#### **SUMMARY OF SUBMISSIONS**

#### PA23/397 – Lot 128 South Western Highway, Byford - Change of Use / Additional Car Parking

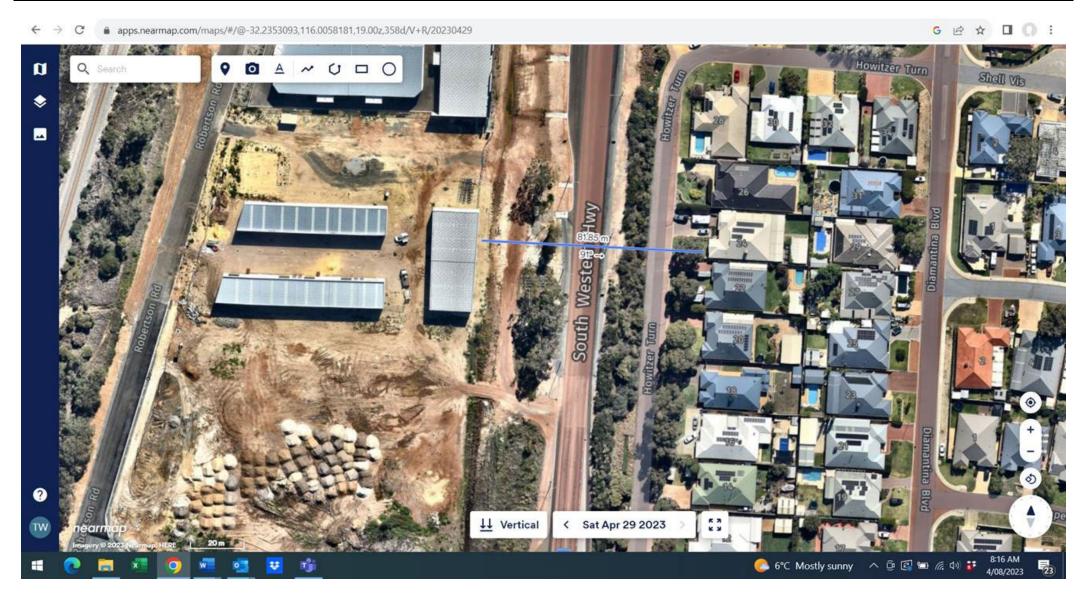
A404202		The bushland proposed for car park extension will affect the black red tailed cockatoo's that regularly nest and feed in this patch of bushland every year.	The subject proposal does not affect any bushland that black red tailed cockatoo's nest and feed in. <u>Incorrect statement, invalid.</u>	No new buildings and works are proposed (other than a redesign of the car parking area) while no vegetation removal is proposed.
